MFN 12-076

**Subject: NRC Requests for Additional Information (RAI) Related to the Audit of the Economic Simplified Boiling Water Reactor (ESBWR) Steam Dryer Design Methodology Supporting Chapter 3 of the ESBWR Design Control Document – Draft Response for RAI 3.9-285**

**Draft Response for RAI 3.9-285**

**NRC RAI 3.9-285**

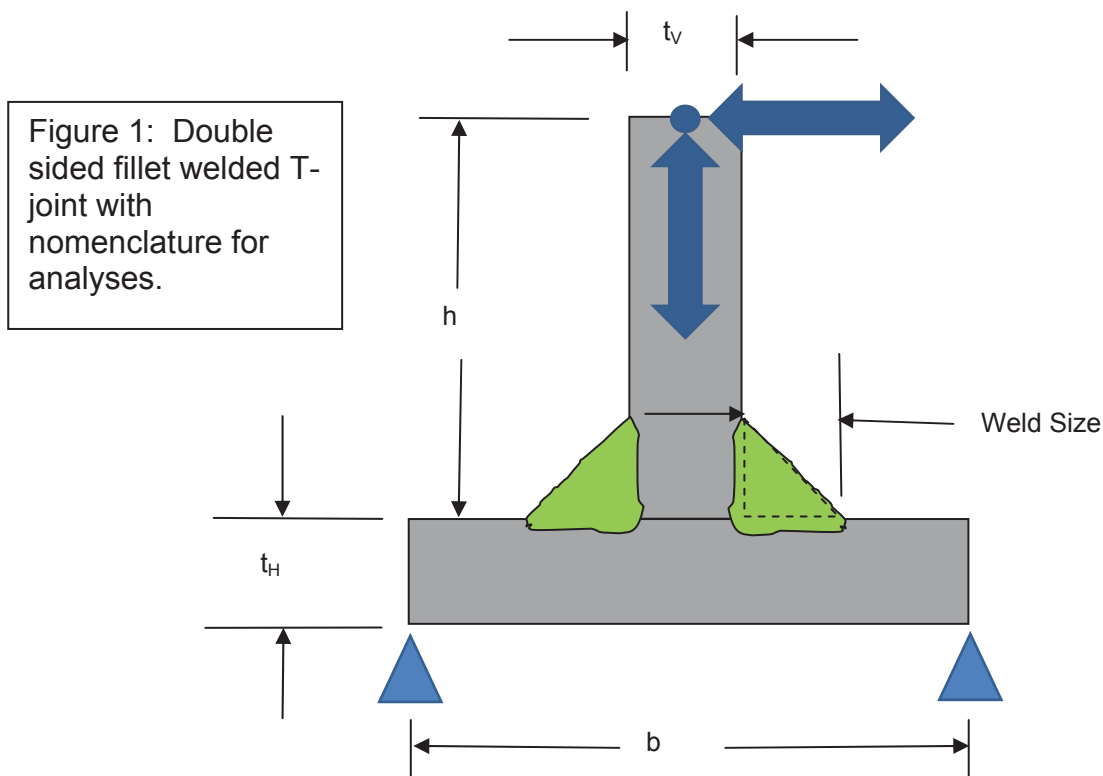
*At this time, the staff is seeking a more comprehensive, quantitative technical basis for GEH's conclusion that method (2) provides equal or greater conservatism, compared to method (1). To this end, the staff requests GEH to perform a series of simple confirmatory analyses that the staff can reference in its safety evaluation of this issue. The basic model is a T-connection of 304 stainless steel plates, which may be considered to be of infinite longitudinal length. A unit strip may be used, reducing the problem to 2-D. The basic loading is in-plane membrane force and out-of-plane bending moment applied to the free end of the vertical (web) plate. The horizontal (flange) plate is constrained at both ends.*

*The staff requests the applicant to conduct a parametric study, varying the lengths and thicknesses of the 2 plates, and the ANSYS shell element refinement. The shell element refinement should be varied by a factor of ten, and should envelope typical shell*

element lengths used in the steam dryer shell models. For each configuration, analyze a “unit” membrane force, a “unit” bending moment, and both applied simultaneously.

Using the shell element stress results from the ANSYS analyses, calculate the peak alternating stress intensities using method (1) and method (2), for each permutation. In the method (1) calculation, assume a range of acceptable fillet weld sizes, based on the thicknesses of the plates being joined. In the method (2) calculation, tabulate the results with and without the *[[ ]]* defined in the last paragraph on page 5 of 37 of Reference 1. Given the simplicity of the model and loading, an extensive parametric study should be designed and implemented, to confirm the validity of method (2). In addition, as a check on the implementation of method (1), compare the results of method (1) to alternating stress intensity predictions “using traditional weld stress formulas”, as defined in B. on page 5 of 37, assuming complete load reversal (stress ratio = -1), for a representative subset of cases.

The example provided during the 2012 NRC staff audit was RAI 3.9-215S01 Part B (ref. 1). The staff member requested background on GEH’s (3) approaches to determining stress in steam dryer welds. These (3) approaches are described in RAI 3.9-215S01 Part B:

- 1) *[[ ]]*, the SCF of 4 is applied *[[ ]]*.
- 2) *[[ ]]*, the SCF of 1.8 is applied *[[ ]]*.
- 3) *[[ ]]*, the SCF of 1.8 is applied *[[ ]]*.

The theoretical basis was explained by GEH during the audit, additional information can be found in license topical report NEDE-33313P-A (ref. 2) and the response to RAI 3.9-215S01 Part B. These approaches were previously accepted by the NRC Staff as documented in NEDE-33313P-A. The RAI questions the basis for method (2) and GEH's limited presentation of the method's proof of acceptability.

To provide information to conclude that method (2) provides a more conservative result than method (1) the NRC Staff requested GEH to perform additional analyses. The NRC Staff requested that GEH use a T-joint for the analyses and to reduce the configuration to a 2-D approach. A typical double sided fillet welded T-joint used for ESBWR steam dryer design is shown in figure 1, an ASME BPV Code Section III NB-3352 Type V weld joint.
